Comments from India on the GTR for Passenger Vehicle Tyres under formulation by the Working Group on Tyres

Giving below our comments in **yellow highlights** on the previous reference document specifically on the subjects of Tyre Markings and Test Methods pertaining to Tyres under various categories for Harmonized High Speed and Low Pressure Tests.

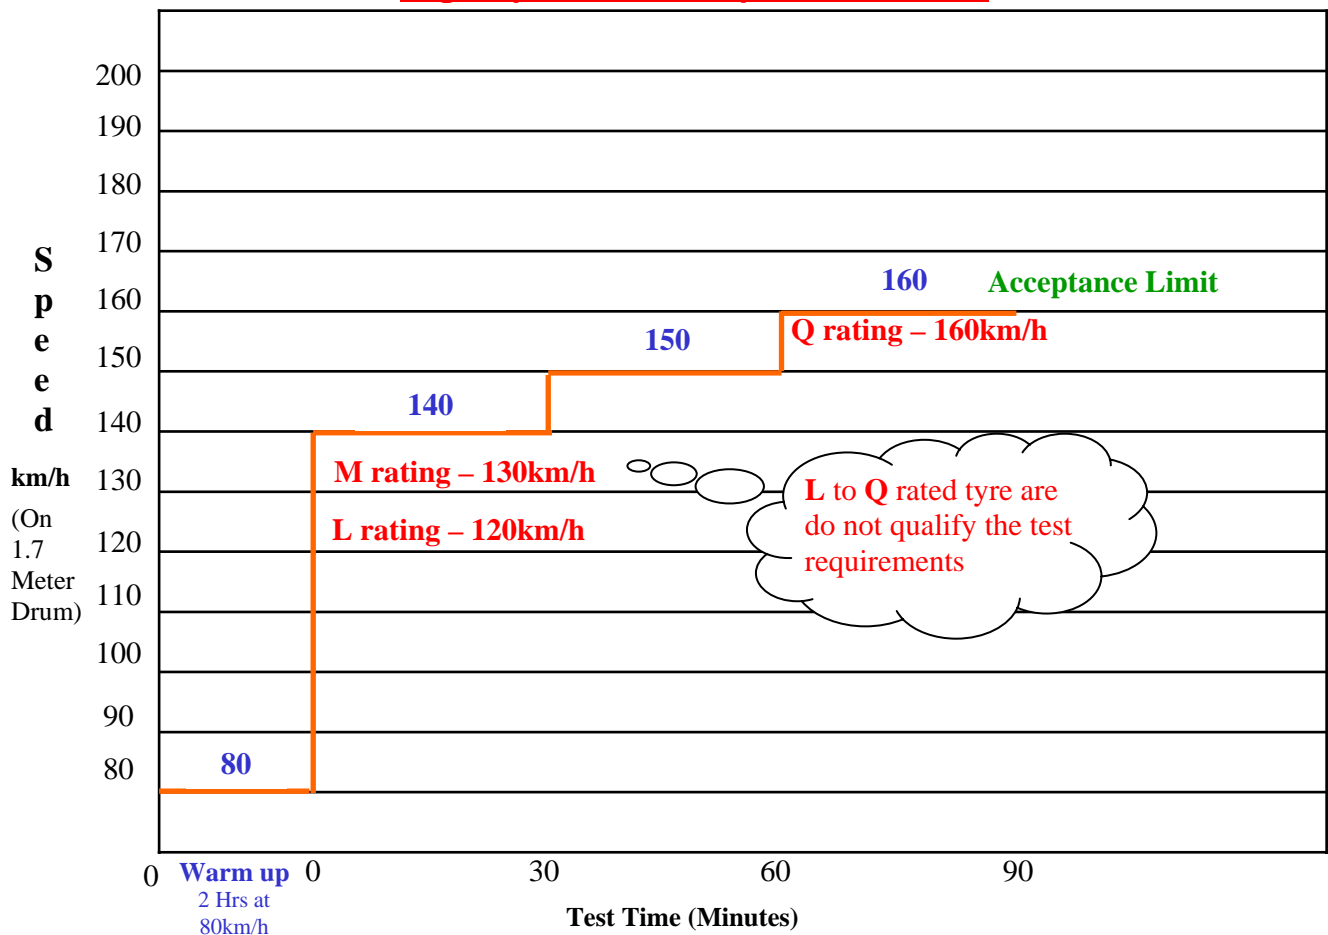
FMVSS 139 Hi-Speed test (1.70 m drum) is having following steps for testing the tyres

120' @ 80 km/h (Break-in & cool-down)  
30' @ 140 km/h  
30' @ 150 km/h  
30' @ 160 km/h

Based on the existing running sizes in India, there is a group of sizes which have speed ratings from "L" to "Q" (Which is 120 km/h to 160 km/h). This group has max. load capacity of less than 1250 kg , hence does qualify under category of tyres being covered under GTR. Examples of such tyres are

This group by virtue of its speed rating range cannot be tested as per FMVSS 139.

The tests applicable to such types of LT tyres to be clearly defined & addressed . For example such tyres may not need a high speed test but can have step load test like ECE Regulation No. 54.

**Harmonized High Speed Test  
for speed rating Below "S"**

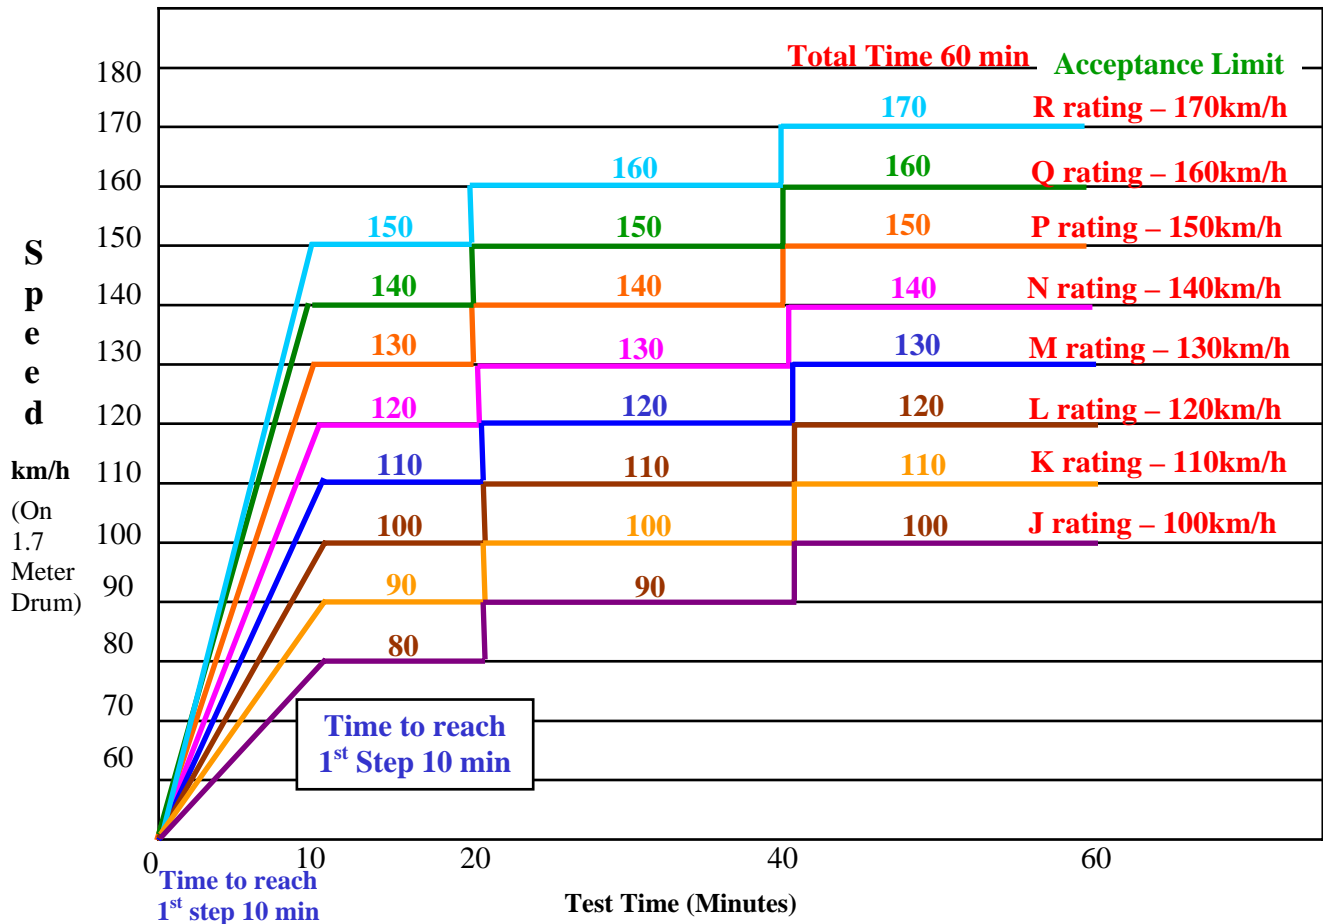
**High speed test for tyres having speed capability below "S"**

**Steps for Hi-Speed test (1.70 m drum) for tyres having speed capability below "S"**

Initial Test Speed : Speed corresponding to speed category symbol minus 20 kmph

Time to reach initial test speed - 10 min  
Duration of 1<sup>st</sup> Step - 10 min.

Second Test Speed: Speed corresponding to speed category symbol minus 10 kmph  
Duration of 2<sup>nd</sup> Step - 20 min.

Final Test Speed : Speed corresponding to speed category symbol  
Duration of Final Step - 20 min.

Total Test Duration is 1 hr.
